Horowhenua County Council

PERMIT No. 15880
C024145LOCALITY Waikanae

APPLICATION FOR BUILDING PERMIT

Particulars of Building: Foundations: concrete Walls: timber Roof: tileTotal floor area: 231 m² 237 sq. metres. front = 16.6 1st = 7.2 (garage = 3.6)2. Purpose for which every part of Building is to be used or occupied. (Describing separately each part intended for use or occupation for a separate purpose) Garage room, double garage, 3 bedrooms, living room, dining room, family room, kitchen, bathroom3. Allotment: 460 m²Lot: 2D.P.: 55 724Section: 35-663Area: 460 m²Block: WALKWAYS.D. WALKWAYLocality: Edge water ST4. Owner's Full Name: NICHOLAS HENRY BRANLEYAddress: P.O. Box 365 Parua

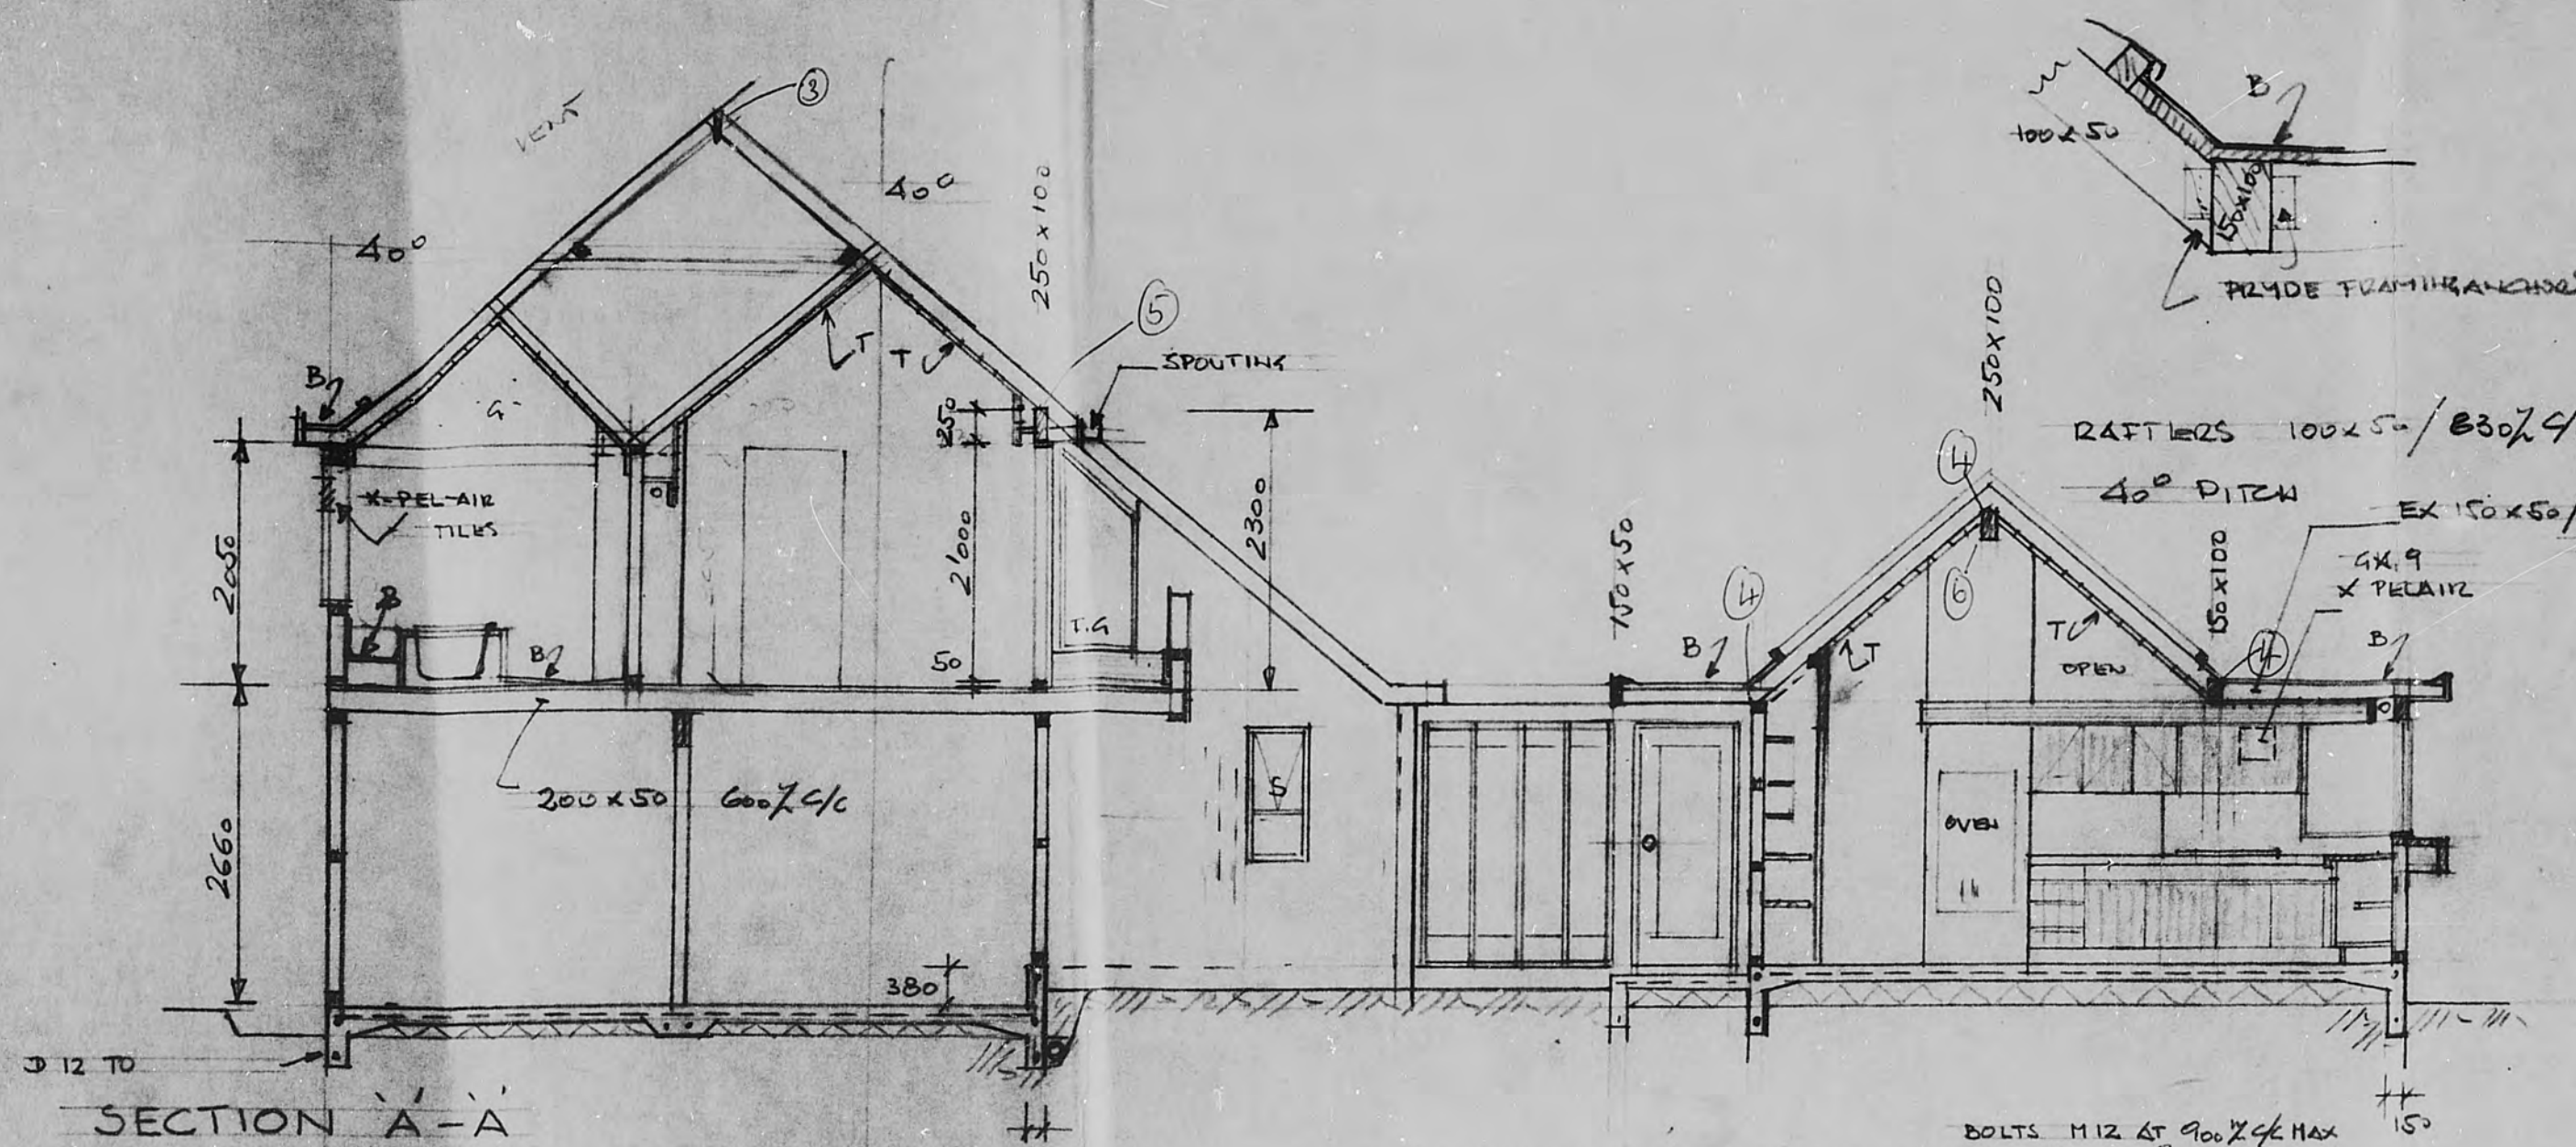
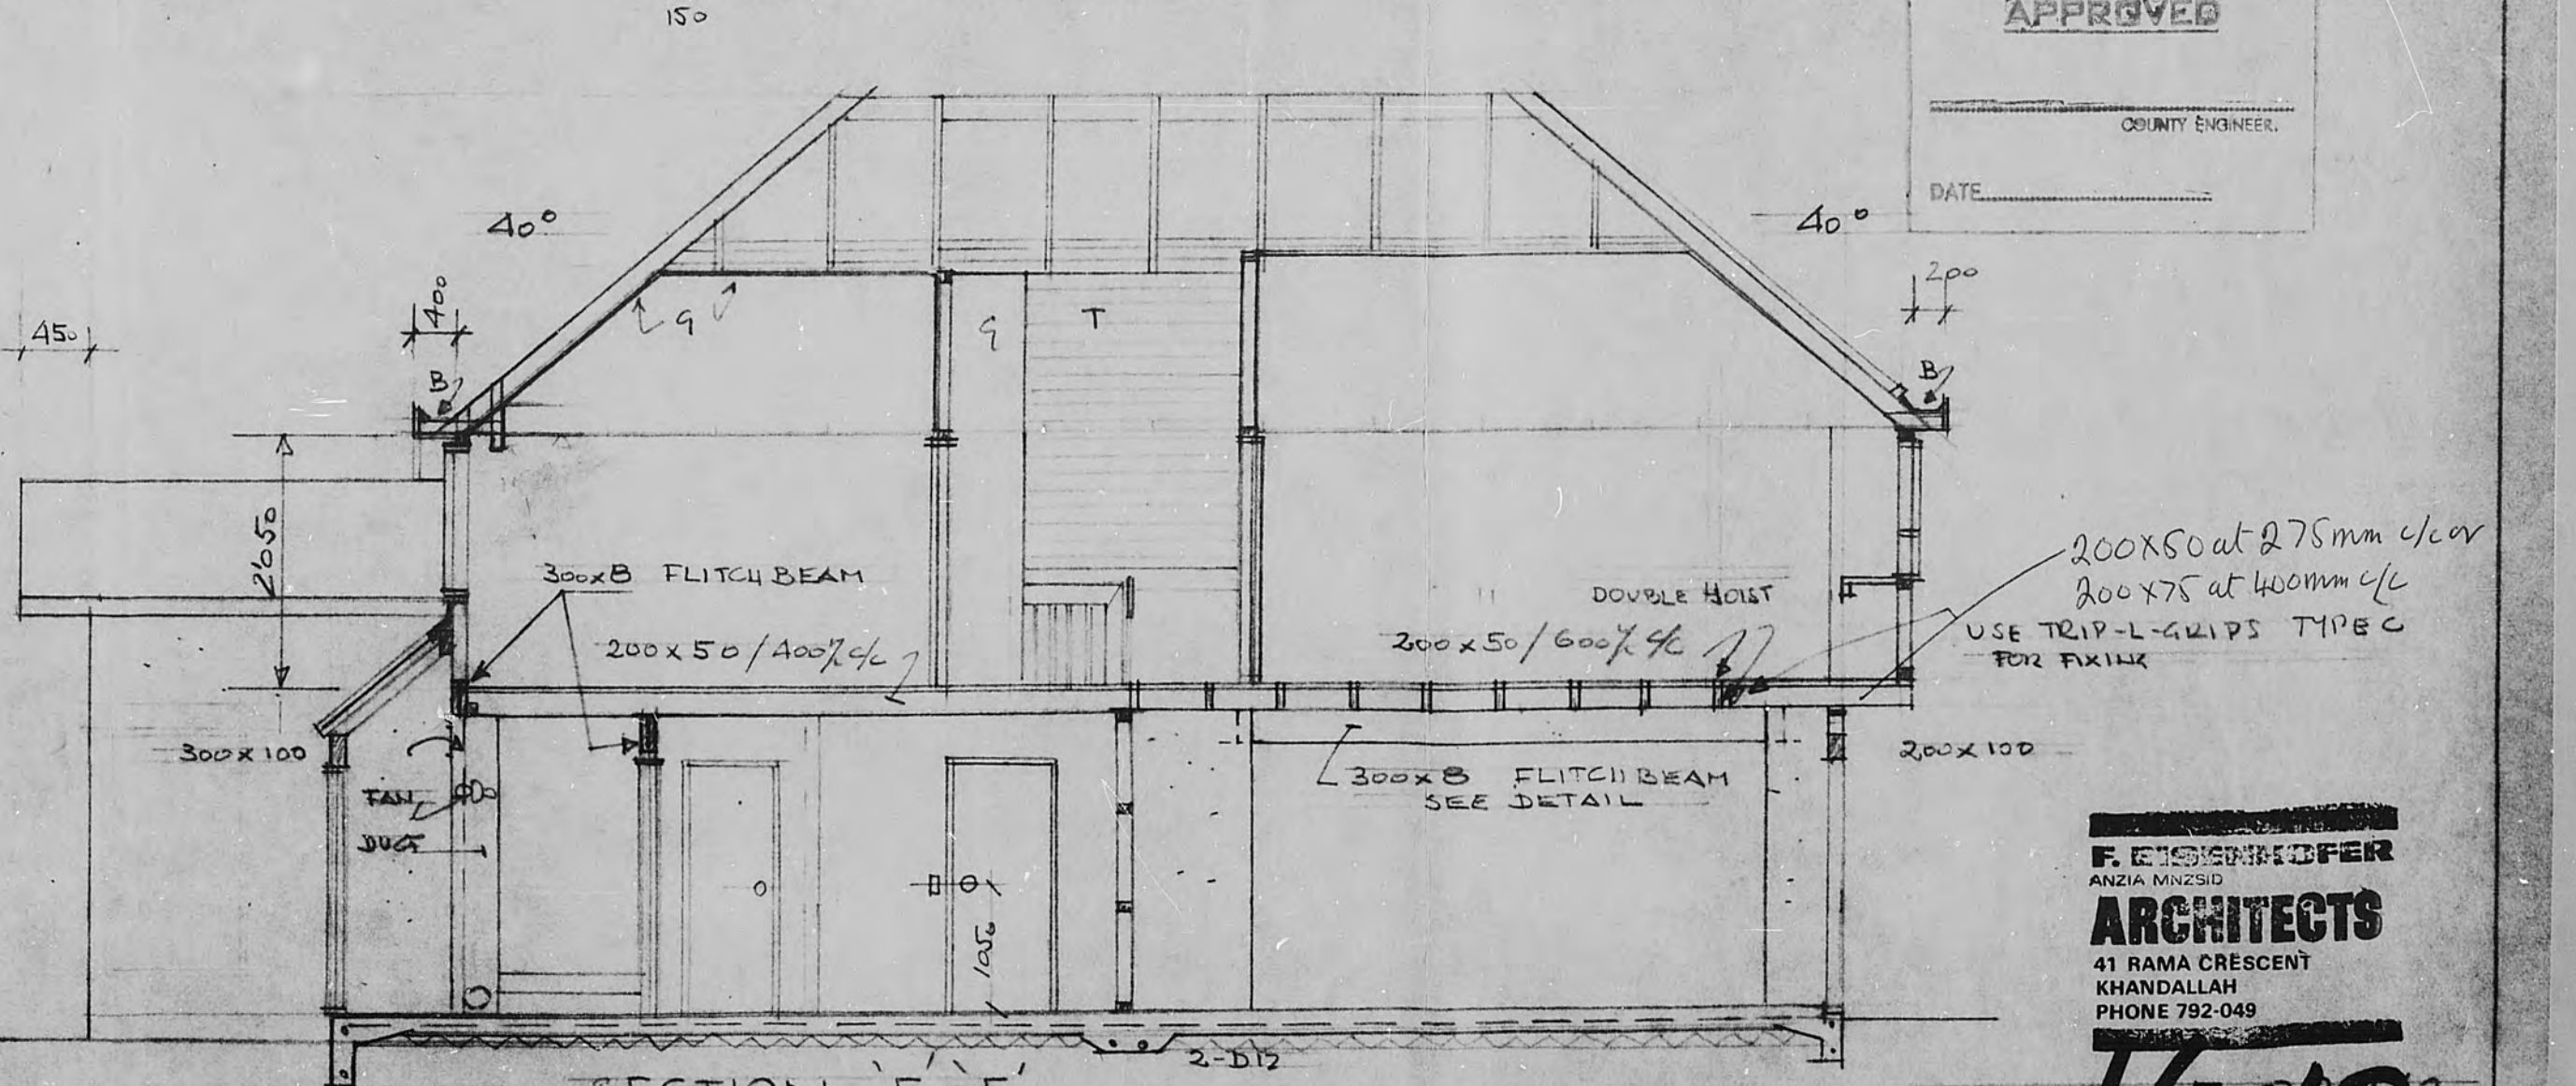
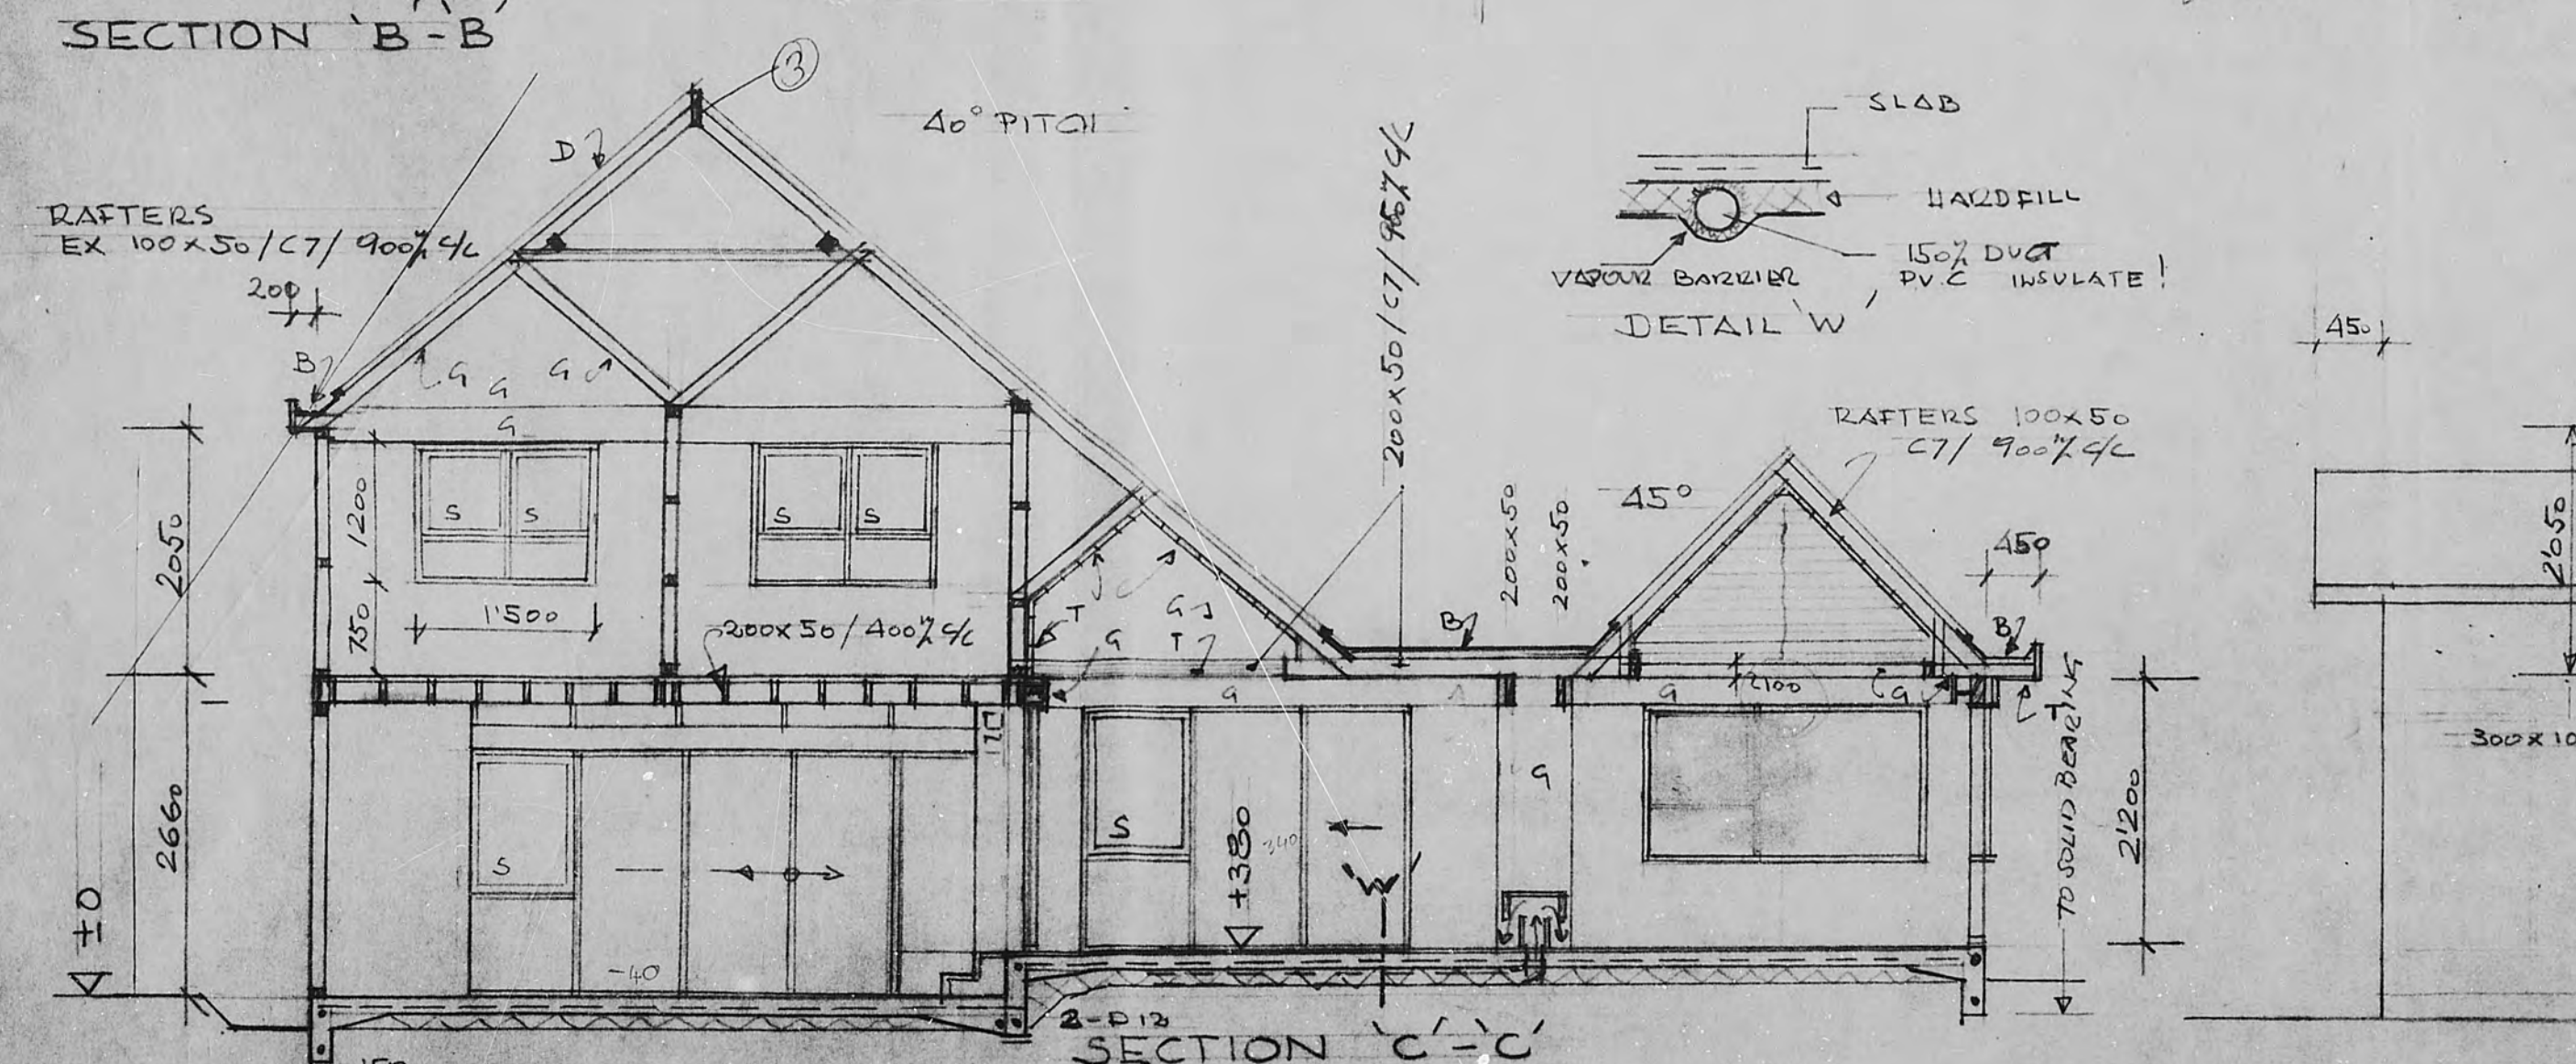
- Notes
- Foundation to HCC detail S/309A. Reinforce foundation to the storey area to have 200mm wide footings (X 150mm thick) with reinforcement and R 4 ties as required by NZS 3604 cl 4.6.4 and cl 4.6.4.6
 - Provide pair of 4N (mm) nail plates to each post embedded on section B-B
 - Min size of ridge in this area would be 150x25
 - Strap head and secure foot of rafters (to roof area supporting sloping ceilings) as required by NZS 3604 cl 6.6.1.5 and 6.6.1.6
 - Where limits exceed 2.7m clear span it will be necessary to strap rafters to double studs and double studs to sub floor framing as required by NZS 3604 cl 6.6.1.5 + 6.6.1.6
 - Ridge beam over kitchen to be supported on wall in the region of the oven.
